MIL-C-25830A(USAF)
Amendment 2
15 August 1961
Superseding
Amendment 1
25 August 1960

MILITARY SPECIFICATION

CLIP-IN SUBASSEMBLY MHU-20/C

This amendment forms a part of Military Specification MIL-C-25830A(USAF), dated 29 March 1960

FIGURE 16

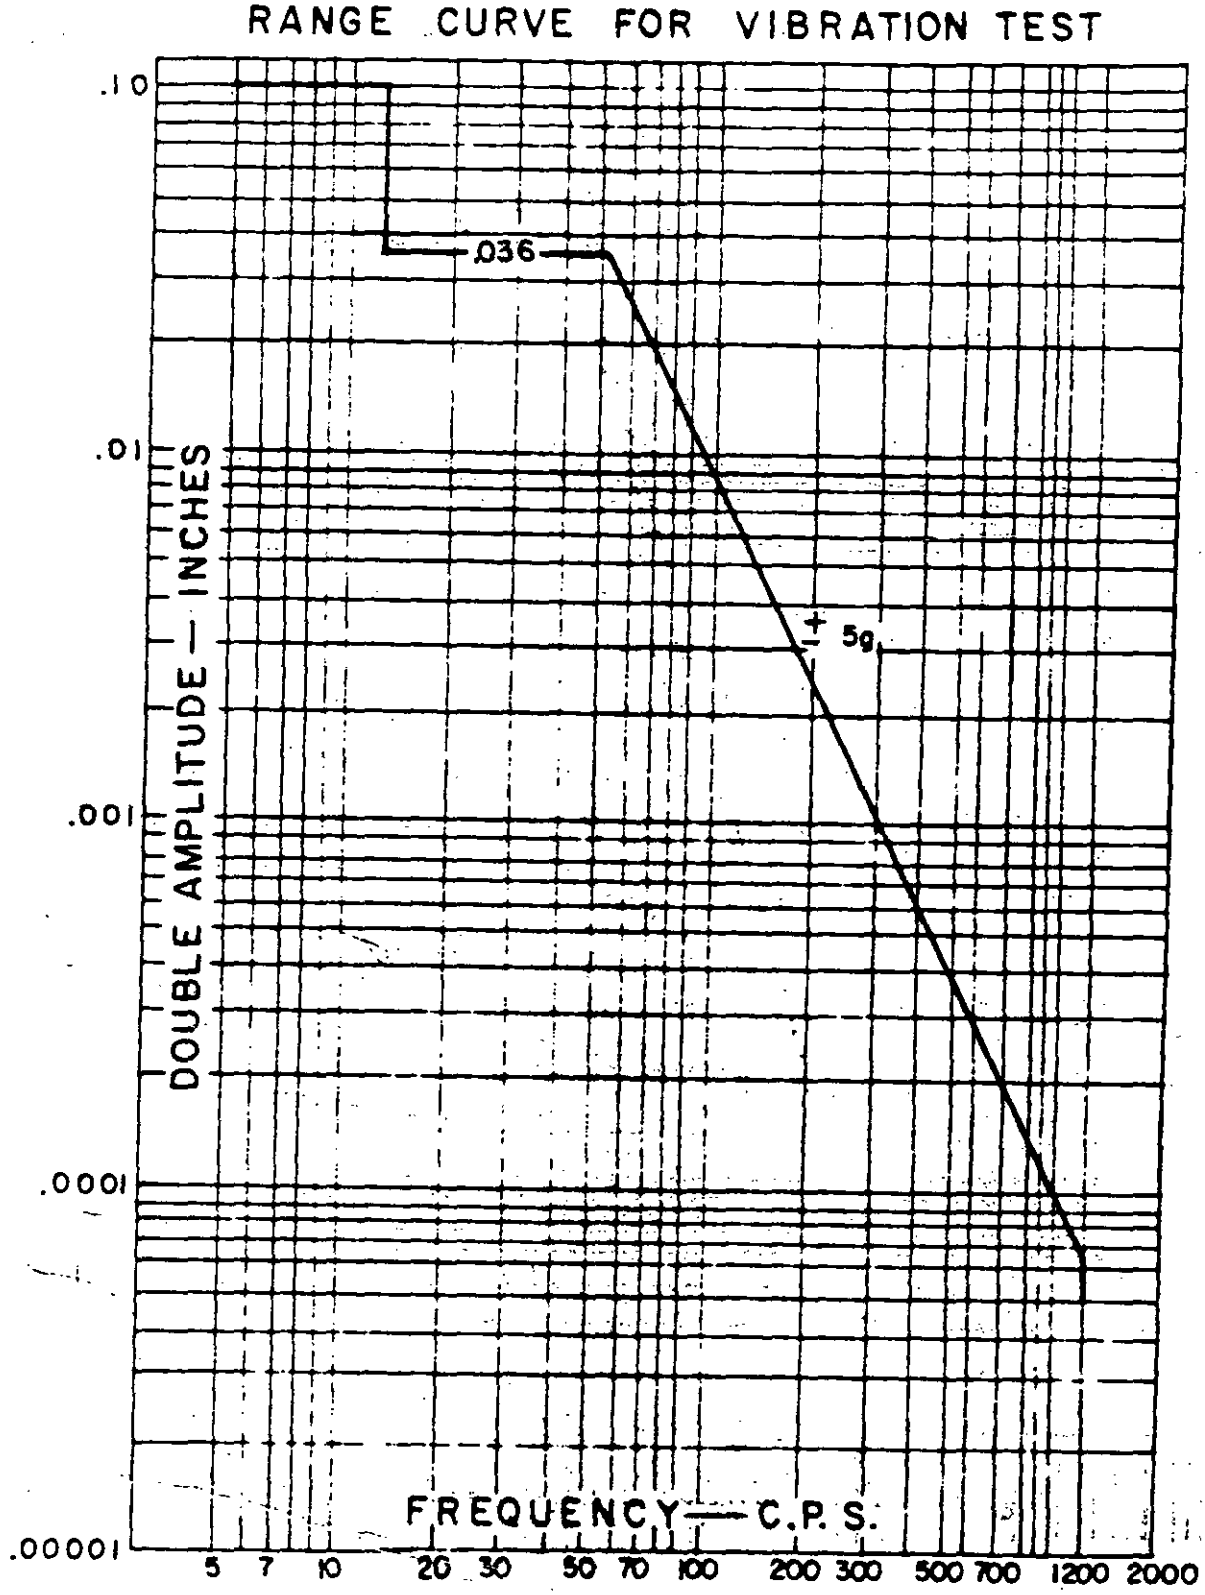
Page 49: Remove figure 16 and substitute therefor corrected figure 16 which forms part of this amendment.
